City of Ramsey
Agenda
Environmental Policy Board (EPB)
Monday, June 12, 2023
6:30 pm
Council Chambers, 7550 Sunwood Drive NW

Consider Natural Resources Aspects of Proposed Site Plan for Aldi (Project No. 23-105)

Consider Natural Resources Aspects of Proposed Site Plan and Plat for Bunker Lake Industrial Park (Project No. 23-106); Case of PSD, LLC

LANDSCAPE PLAN	
Drawing Name:	ISG Project No.
Type: V7.0 ER	23-21339
Drawn By: AE	C-510
Designed By: AE	Drawing No.
Reviewed By: MRW

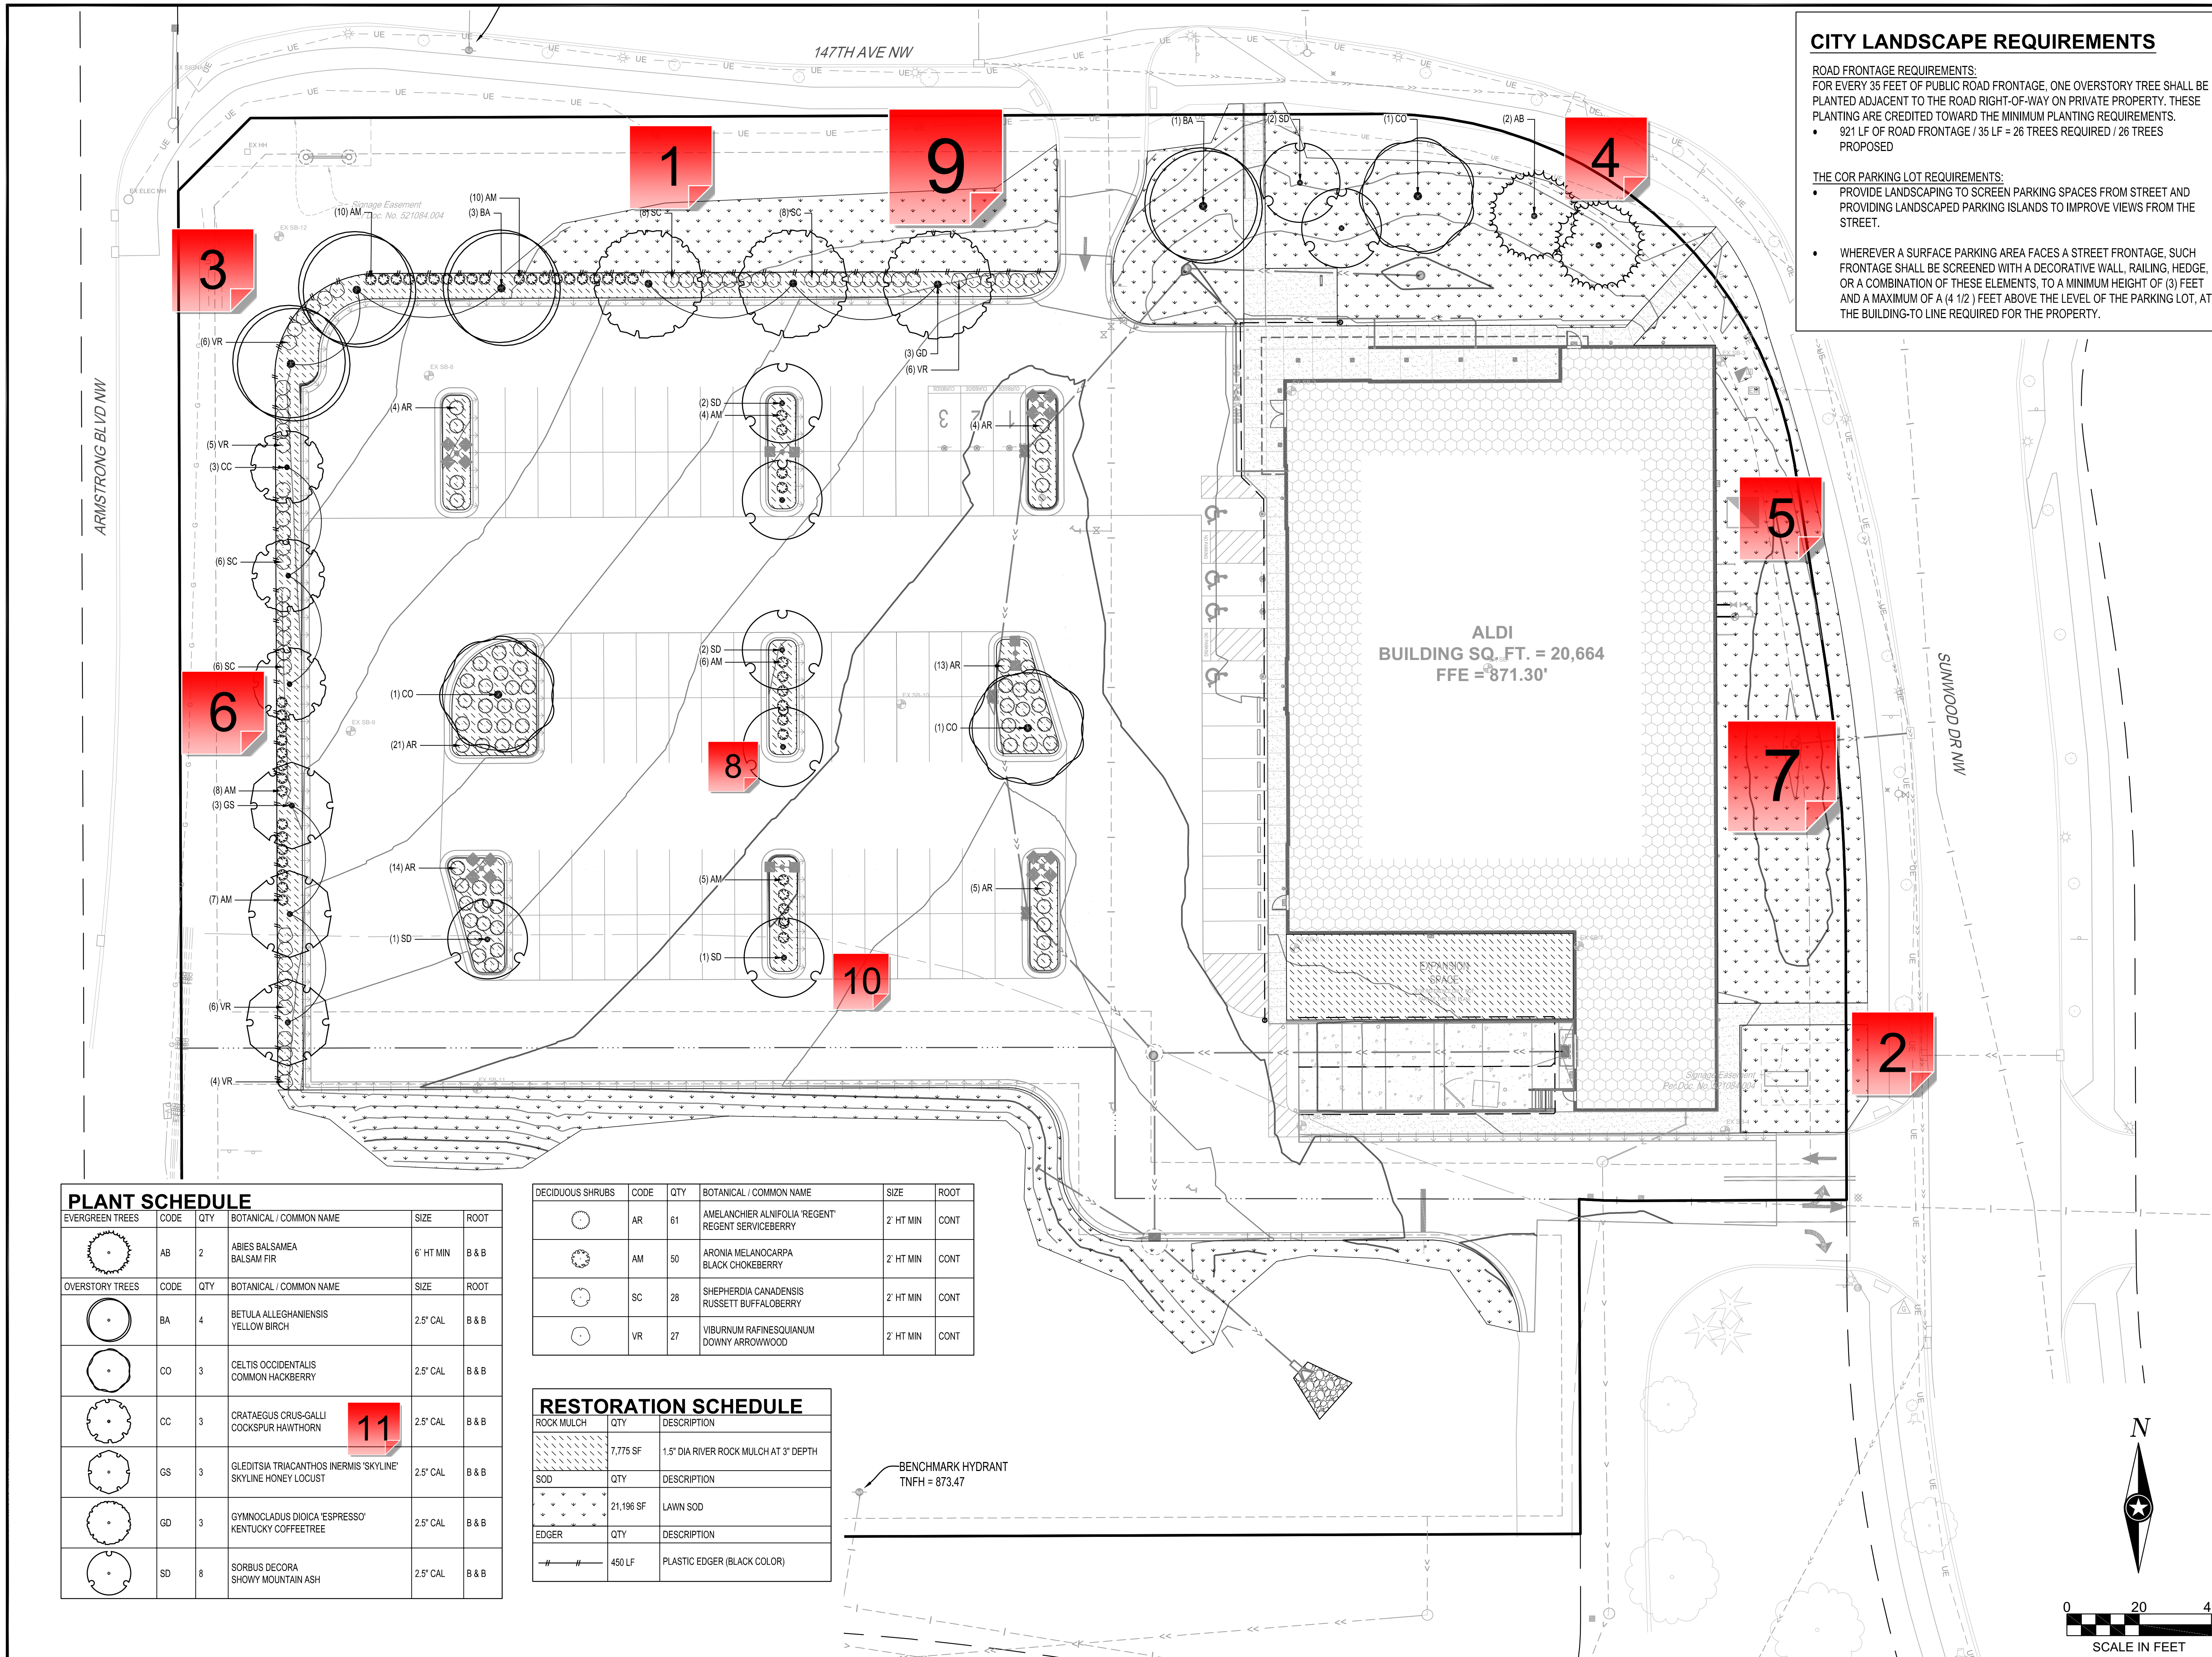
In lieu of at least 40% building frontage, you will need to add a decorative wall (see east end of Sunwood Drive) to provide the required hardscape.

Please consider foundation shrubs and plantings to enhance your sign base.

Where is snow likely to be stored?

The one place you have windows on the building you are blocking with evergreens. Please consider something else.

If all of this utility equipment must be here, please add a decorative screen wall.

Why are the trees planted so close to the parking lot? Why not center them in the green spaces?

This greenspace should be 'enhanced' somewhat by adding plantings (trees and shrubs).

Do not use riverrock in the parking lot islands. It's already a harsh growing environment and the rock will only absorb heat, which in turn heats the soil, baking the roots. Instead, use an organic type of mulch, such as wood chips or similar. This will not only aid in moderating soil temperature but will also help retain moisture.

Why would sod not be installed up to the edge of the sidewalk? Whatever groundcover exists currently will not have as nice of an appearance as the new sod.

Mountain Ash is at least somewhat intolerant of harsh urban areas. Suggest considering an alternate species for the parking lot islands.

This should be a thornless cultivar.

LANDSCAPE DETAILS

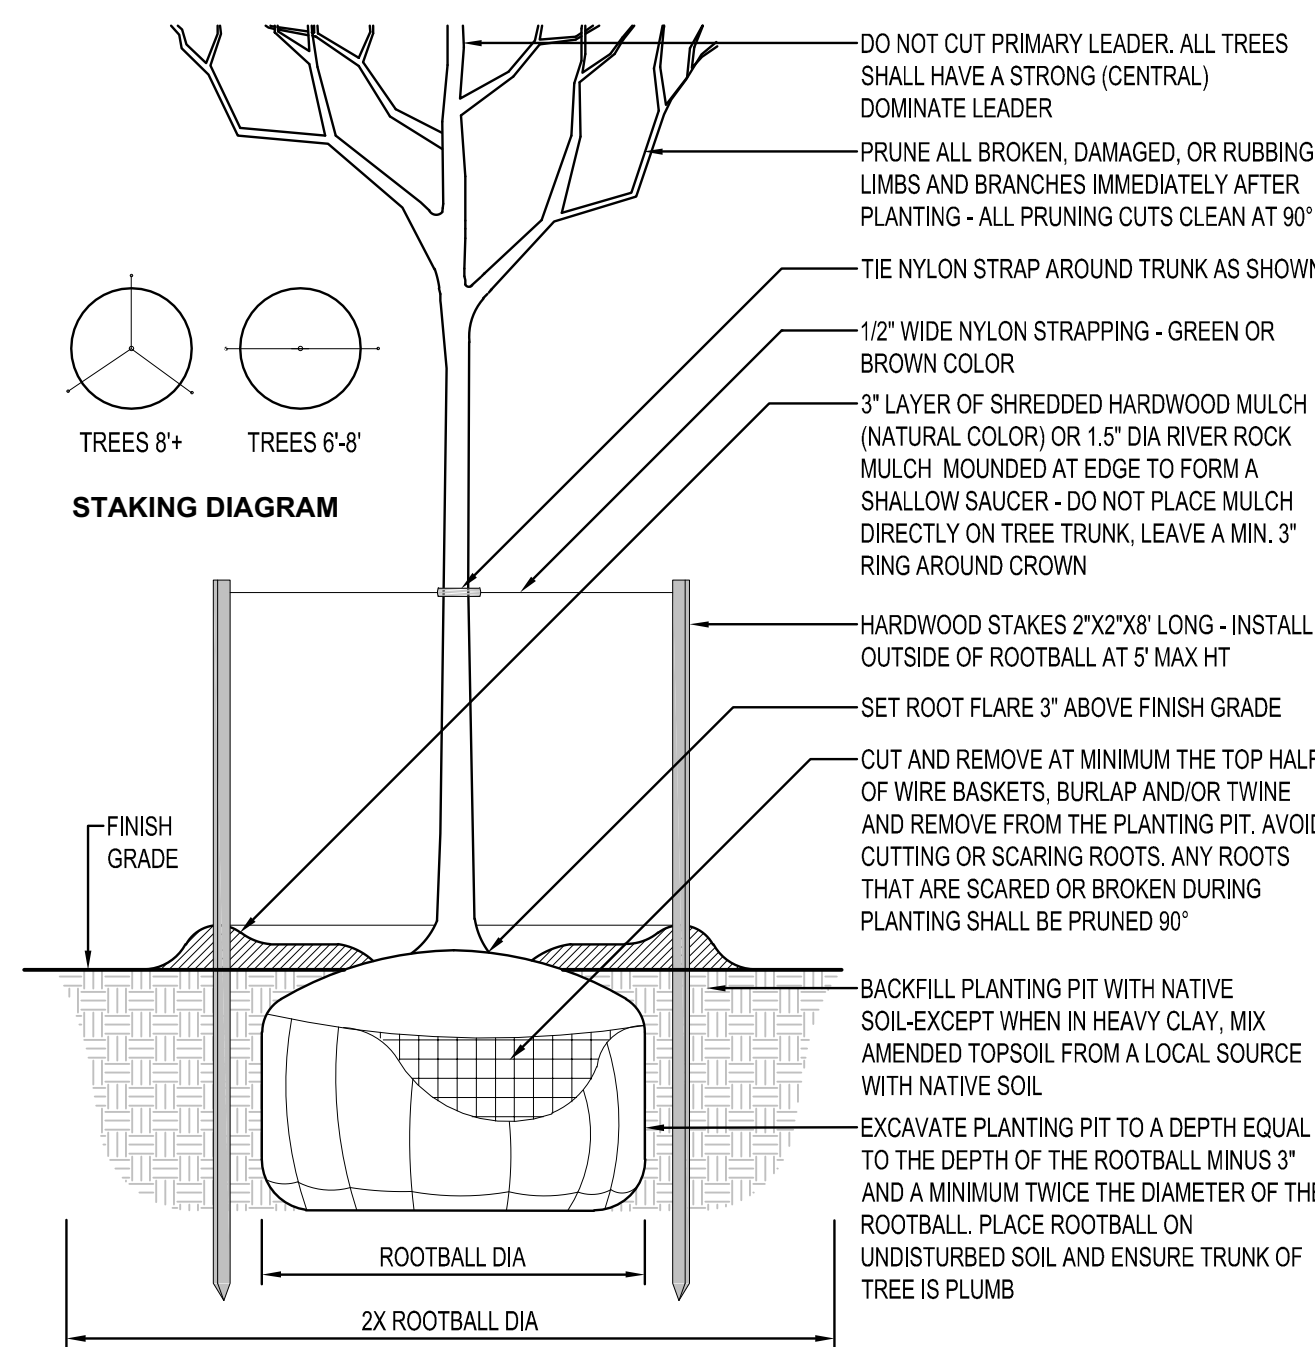
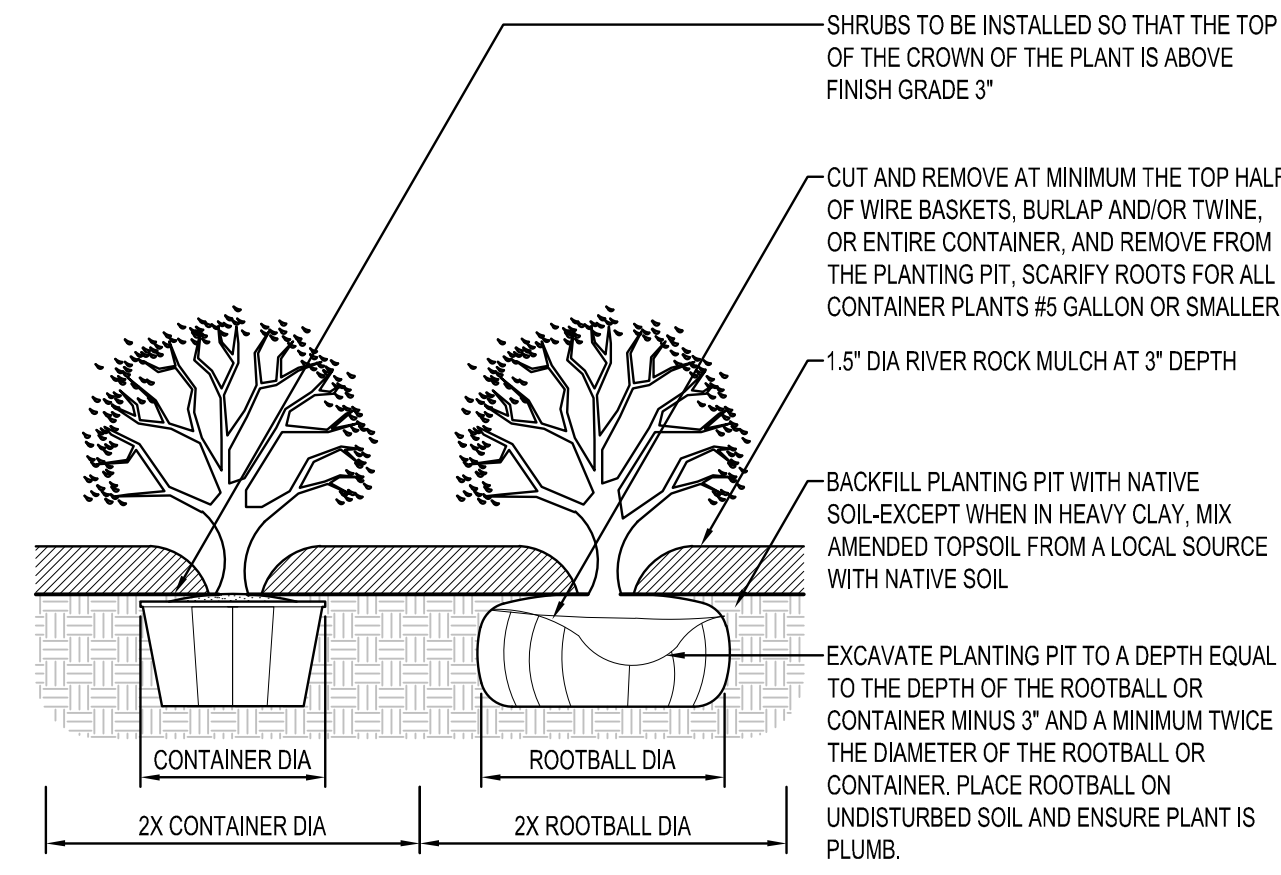
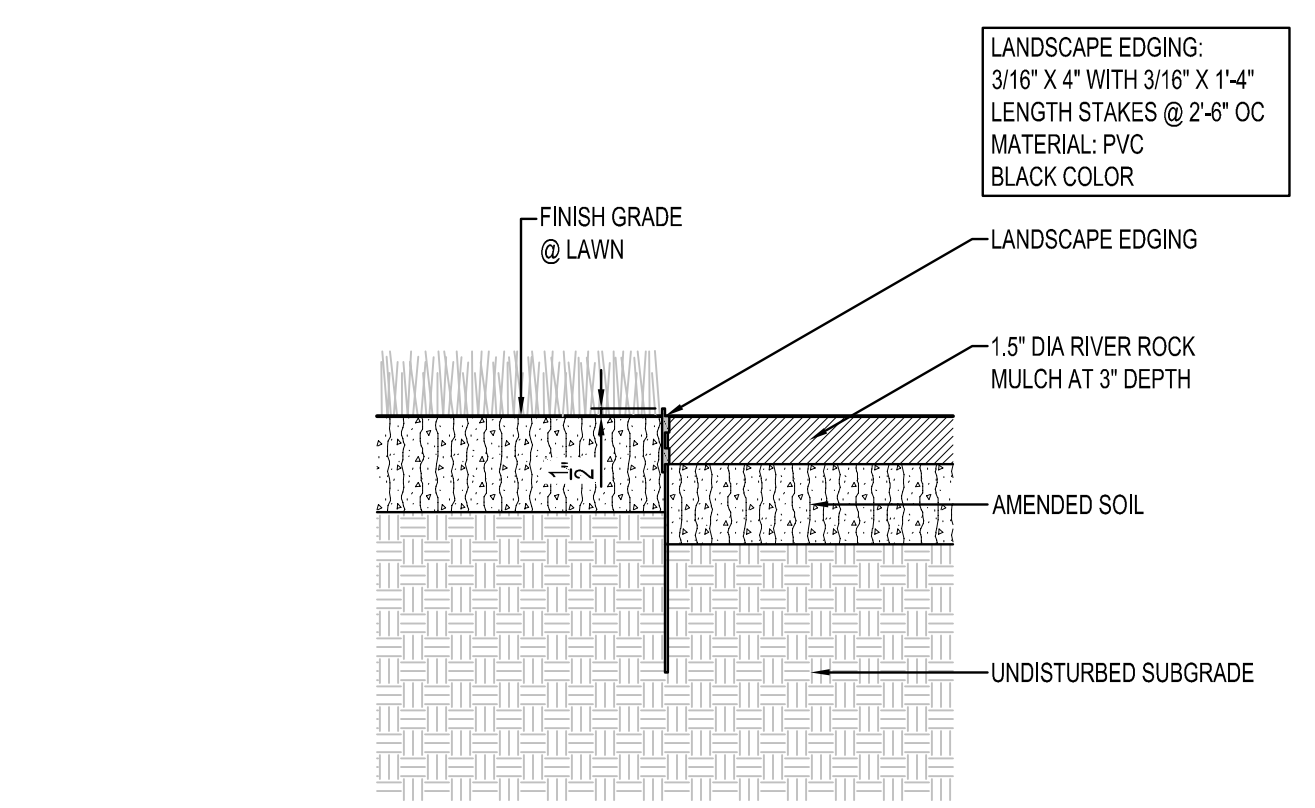
Any deviations from the approved landscape plan require prior approval of the City.

Add note to either this sheet or the Landscape Plan stating that 4 inches of topsoil, with no more than 35% sand content is required over all disturbed areas not otherwise improved with impervious surfacing. A topsoil inspection is required prior to installation of landscaping.

Will an irrigation system be installed? If so, please provide details. Any irrigation system installed shall include a rain sensor and some form of water efficient technology, such as a weather compensating smart controller.
